CLRC

8th August 2001

Summary of Design Status for some Harness Related Issues.

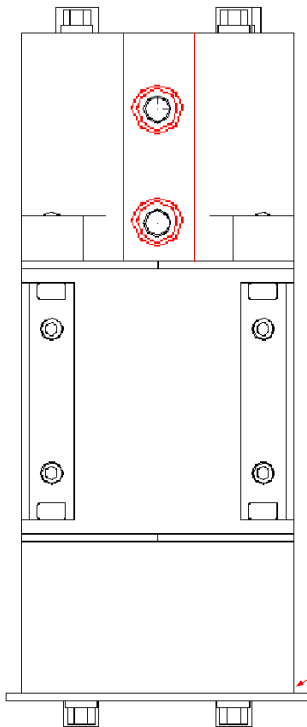
As I understand it, there are rear-bulk-head mounted plug connectors on both ends of this unit. Please add a note that the "Walls have apertures sized such that, when assembled with worst case PCB to wall tolerances, the rims on the mating socket shells will be able to pass through these apertures, giving full connector mating." or some equivalent wording.

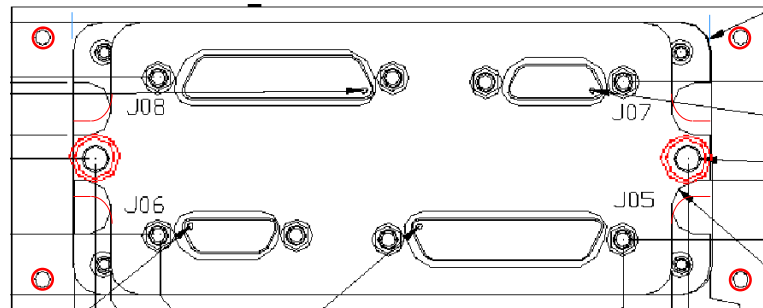
To meet spec, on distance between fasteners when holding RF seal along the unit's two dividing walls, please add 2 fasteners top and bottom

Red shows changes for M2.5 mounting.

Need small amount of extra material on rear web to stop thread insert breakout.

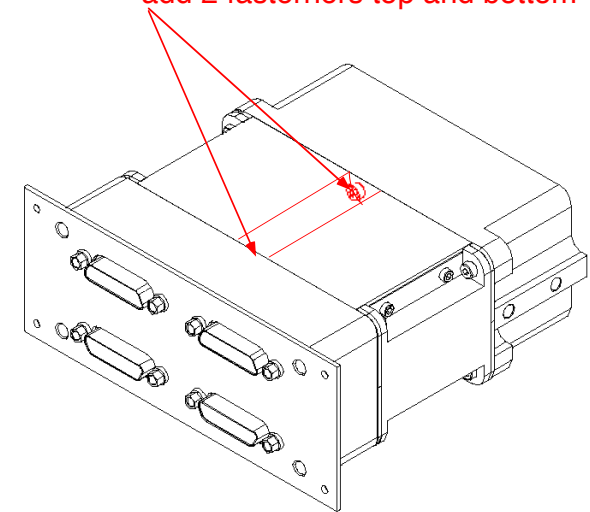
Blue construction lines show front face can be left unchanged, but I've made module's width tolerance downwards only to keep a 40mm rack spacing.

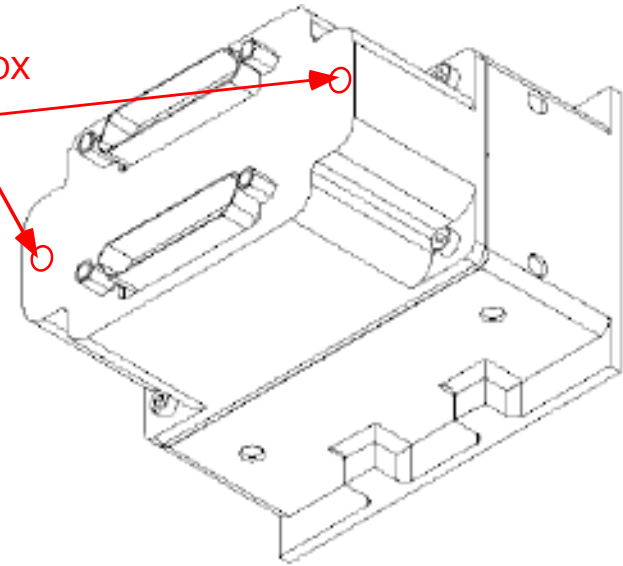
ONLY CHANGE TO FILTER BOX
IS PAIR OF M2.5 INSERTS

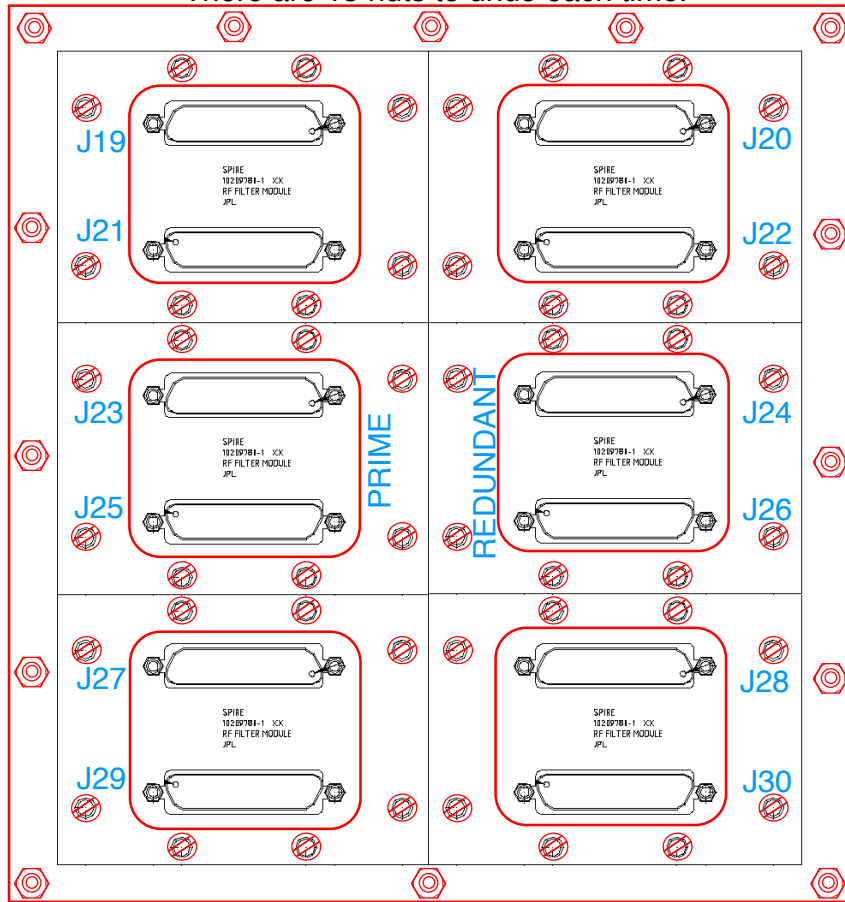
FILTERS ATTACHED TO BACK OF PLATE,
the plate has outward facing studs that pass through FPU clam-shell.
There are 15 nuts to undo each time.

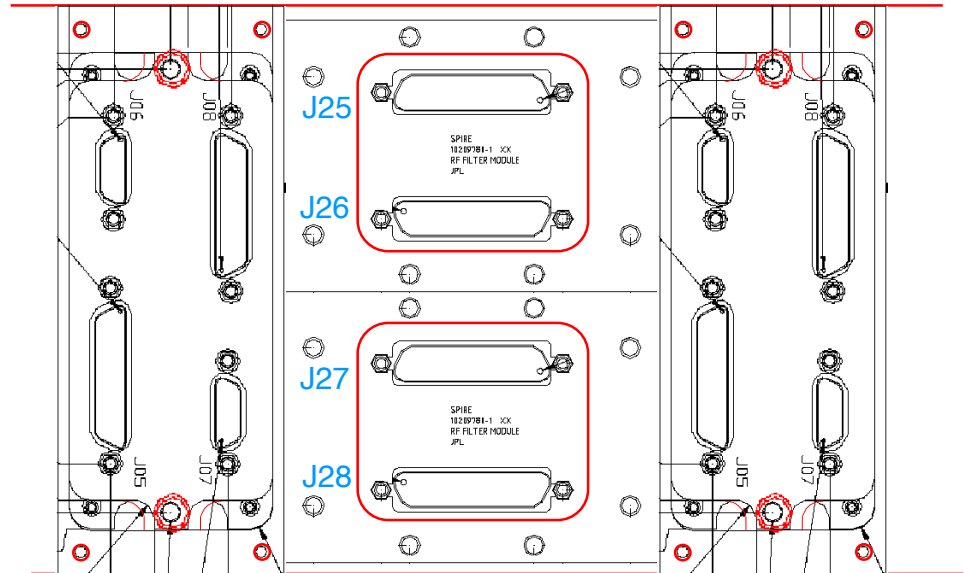
PAIR OF FILTERS IN MIDDLE OF PHOTOMETER JFET RACK
Note that this is not drawn correctly because it shows FCU facing ends
of the filters but FPU facing ends of the nearest pair of JFET modules.
The point is that 2 x 48mm is nicely a little bit less than 100mm.
